Statement of Response to LRD Opinion

Large Scale Residential Development at:

43-50 Dolphin's Barn Street,
Dublin 8.

The Iveagh Trust

Figure 1: Proposed Materiality

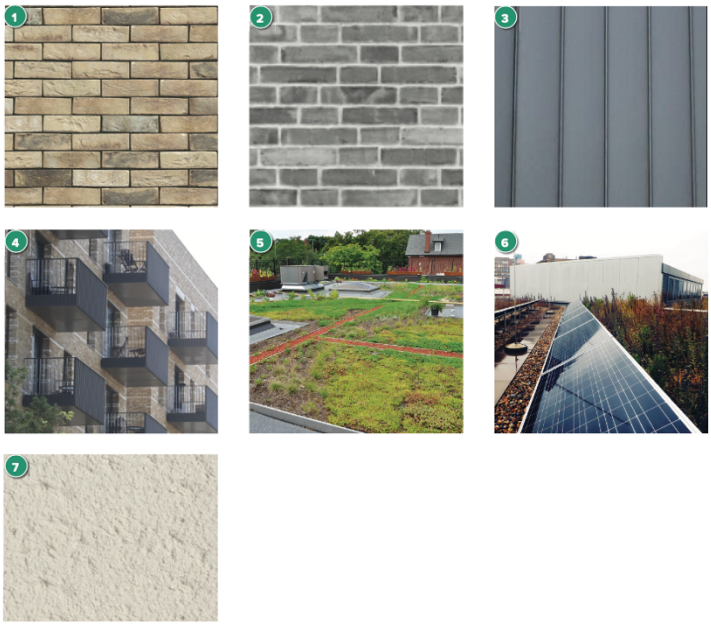
In terms of architectural design treatment, the Planning Authority recommends that the tone and colour of the proposed external finished are reconsidered as the widespread use of grey colouring in the brickwork and cladding as proposed, would fail to positively contribute to the streetscape, or enhance the overall quality of the urban environment. It is suggested that alternative finishes should be considered i.e. warmer colours.

In response to this Item, the LRD application now provides alternative finishes i.e. warmer colours. Figure 1 below shows the proposed materiality of the scheme now presented, chosen by the project architects, CWOB:

The use of brick as the predominant material provides warmth and gives human scale to the facade and is a proven durable facade material. It was also selected for its robustness, domesticity and ease of maintenance. The upper levels utilise a grey cladding material to soften the upper set-back levels and provide variation within the articulation of the façades. The colour of the grey cladding material

use on the upper most floors resonates down through the facade via the expression of the window frames and balcony design.

Figure 2 – Dublin City HDNA sub areas with subject site outlined by black star (extract from Figure 1-2 – appendix 3)

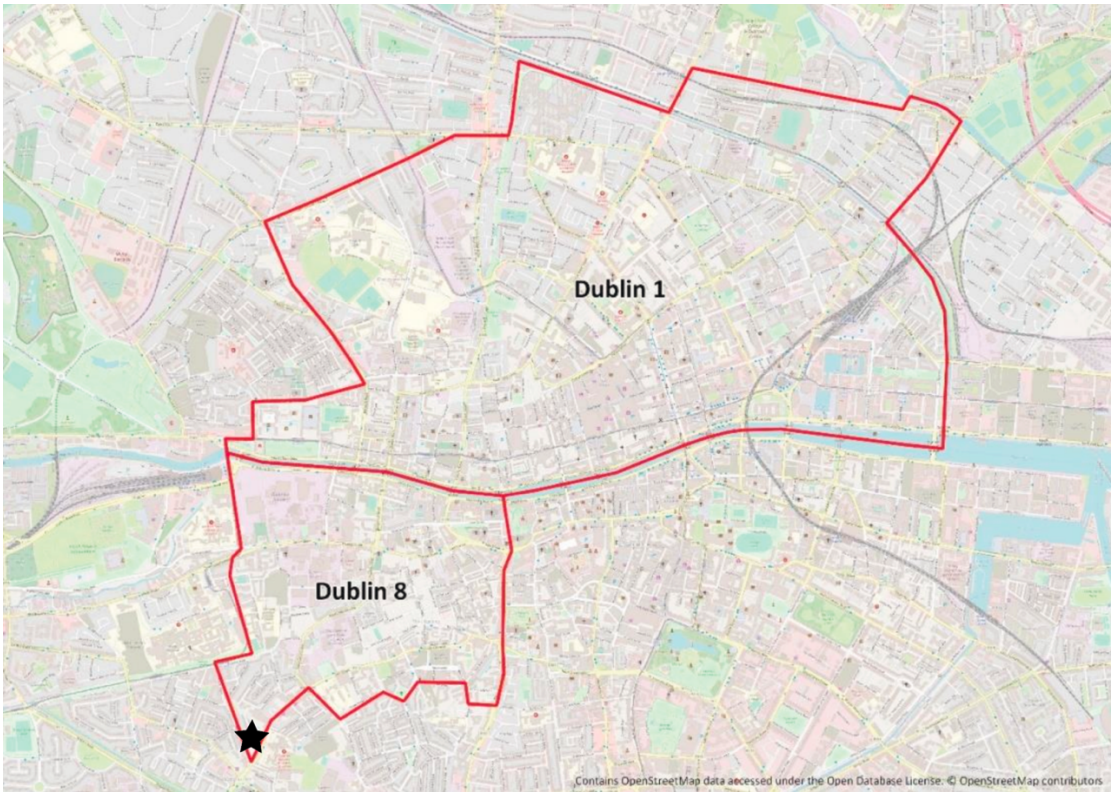
The proposed residential mix does not comply with the mix specified in the Housing Demand Needs Assessment carried out for the Liberties area. Whilst it is acknowledged that Section 15.9.1 of the City Development Plan 2022-2028 provides for a relaxation of the unit mix for proposed social housing and infill schemes, the proposed mix should be clearly justified. Confirmation that Dublin City Council Housing Department supports the proposed residential mix should also be provided with the planning application.

As illustrated in Figure 2 below, the subject site is located within the Liberties – Dublin 8 (indicated by the black star), which was identified for sub-city HDNA analysis. The outcome of these the HNDA indicated increased demand for two and three person households and declining demand regarding single person households.

It's noted that residential accommodation of 15 residential units for more in the Liberties Sub-City Area shall include the following mix of units:

- A minimum of 15% three or more-bedroom units; and
- A maximum of 25%-30% one bedroom / studio units.

However, the Plan states that standards may be relaxed for other social housing needs and/or where there is a verified need for a particular form of housing, such as the subject site. The unit mix has been agreed with DCC's Housing Department, and correspondence confirming same is now submitted to the Dublin City Council Planning Department as part of this application pack for consideration.

Figure 4 – 'Typical Parapet Blue with Green Roof Detail' - DB-2024-01-01 (extract from JJ Campbell and Associates Engineering Services Report)

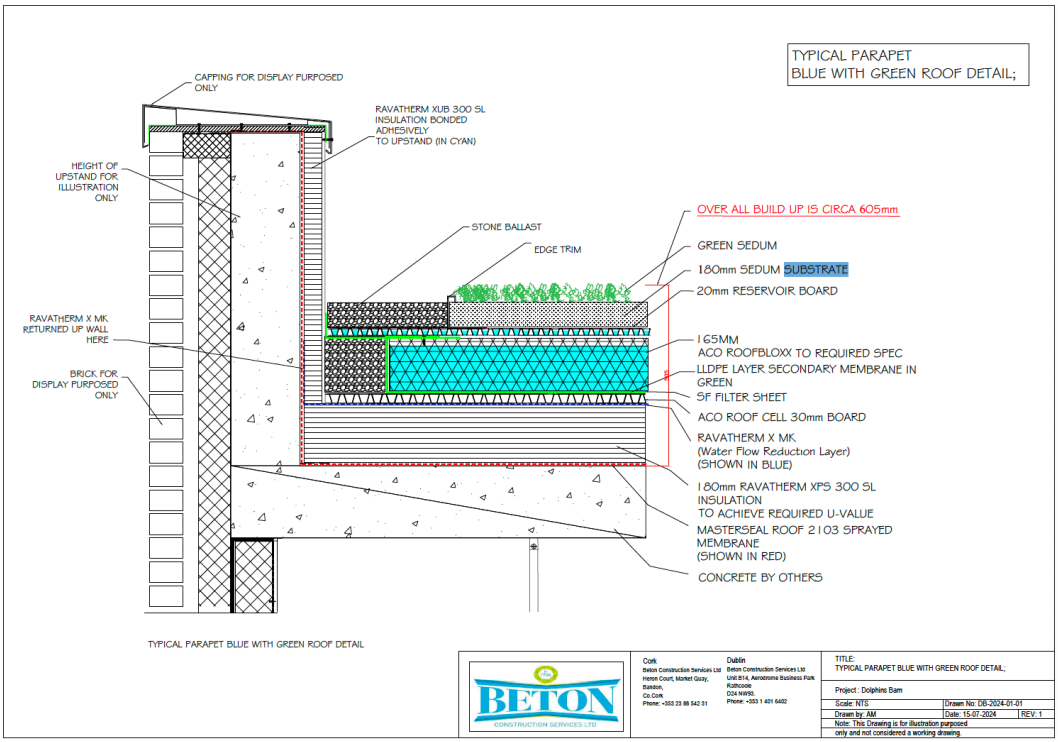
The inclusion of green-blue roofs is welcomed however these could be improved upon to address biodiversity criteria; applicant asked to consider a deeper substrate rather than just the proposed sedum coverage.

The Engineering Services Report prepared by JJ Campbell and Associates refers to a 'Typical Parapet Blue with Green Roof Detail' drawing (dwg. no. DB-2024-01-01) prepared by Beton Construction Services Ltd., which has considered a deeper substrate rather than just the proposed sedum coverage by providing sedum and sedum substrate to be a minimum of 200mm to encourage biodiversity.

Figure 5 – 'Landscape Design – SuDS Strategy' (extract from Landscape Design Statement)

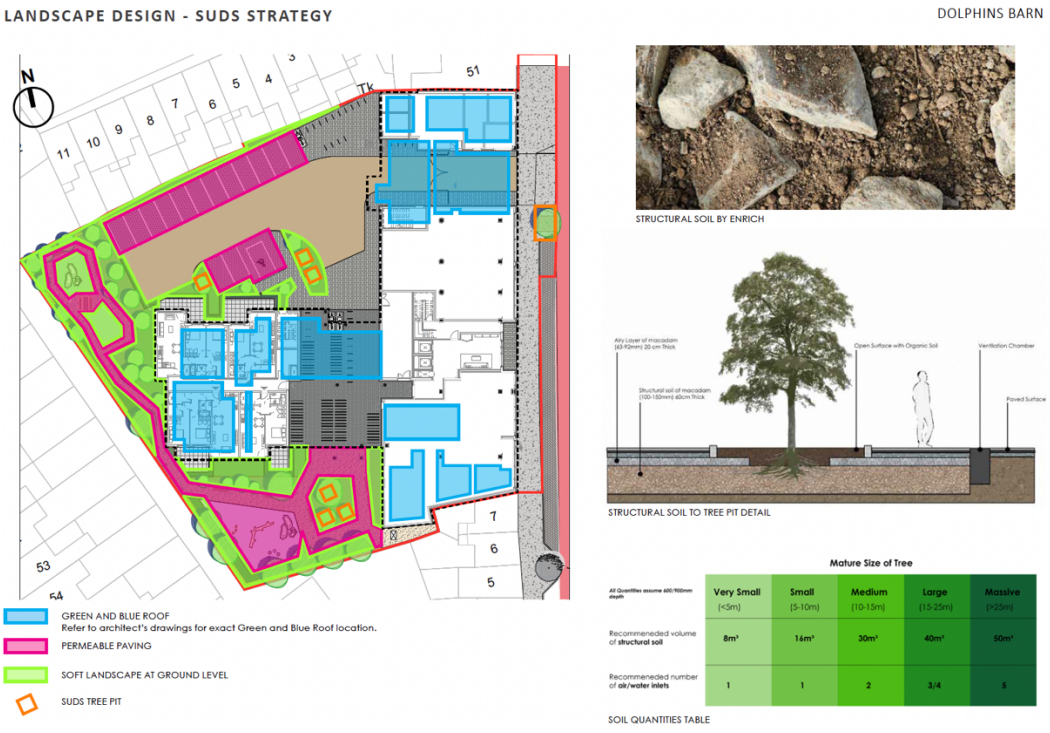
SuDS tree pits are proposed as part of the surface water management strategy however these do not seem to be reflected as part of the Landscape proposals. Ensure clarity and consistency with approach. Also it is important that all SuDS elements are fully implemented as part of the development and not omitted during construction stage.

Please note that 6 no. SuDS tree pits are proposed as part of the subject development. It is proposed to install "GreenBlue" tree pits, which have 20% voids by volume, which reduces the size of the attenuation tank required. Tree pits minimum of 2m x 2m x 1.0Dp x 20% voids: 0.8m³ Storage each.

The project landscape architects Murray & Associates have reflected the SuDS tree pits proposed as part of the surface water management strategy in their 'Landscape Design – SuDS Strategy', as outlined by the orange outline (refer to Figure 5 below), which is included as part of the Landscape Design Statement.

Figure 7 – Approximate location of proposed connection and storm manhole.

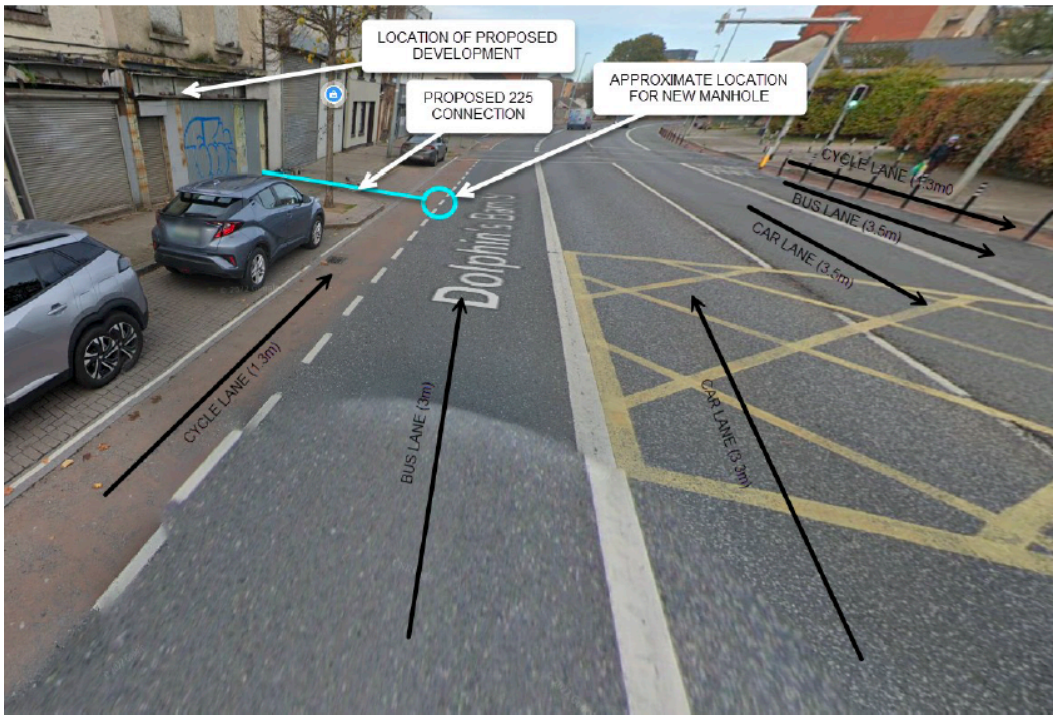
Further clarity is required regarding the proposed surface water outfall MH and connection point. The practicality of proposed construction works on a heavily trafficked road is queried and a better design option may be possible. A separate off-line meeting is recommended to discuss details further.

It is not possible to connect soffit to soffit from the outfall storm manhole to the DCC 225Ø storm because it clashes with the IW 300Ø foul sewer. It is proposed to use a ramp manhole to avoid the clash with the existing 300Ø combined sewer, see detail 1 and 1A on drawing C6. The start of the ramp is 257mm above the invert of the existing storm sewer. All to be confirmed when the road is opened and the exact levels of the existing 300Ø combined sewer and existing 225Ø DCC storm are determined. The proposed connection has been kept as deep as possible to avoid clashes with services in the path and road. A GPR survey to confirm existing services shall be carried out before the connection commences.

The existing DCC 225Ø storm sewer is located on the near side of Dolphins Barn Road, on the road heading into the city centre and on the same side as the proposed development. The existing storm manholes shown on the topographic survey confirm the existing storm sewer runs under the white line between the bus lane and cycle lane, see figure 01 below. Dolphins Barn Street is comprised of a cycle lane (1.3m), bus lane (3m) and a car lane (3.3) heading into the city centre. Heading out of the city centre there is a cycle lane (1.3m), bus lane (3.5m) and a car lane (3.5m). The overall width of Dolphins Barn Street at the proposed location for the new manhole is 15.9m. To construct the new storm manhole, it is proposed to temporally cordon off the cycle lane and bus lane heading into the city centre, diverting buses and cyclists around the proposed manhole and onto the car lane heading into town.The cycle lane, bus lane and car lane heading out of town are unaffected by the works. No temporary traffic signals or stopping of vehicle movements heading into town is required to construct the new storm manhole.
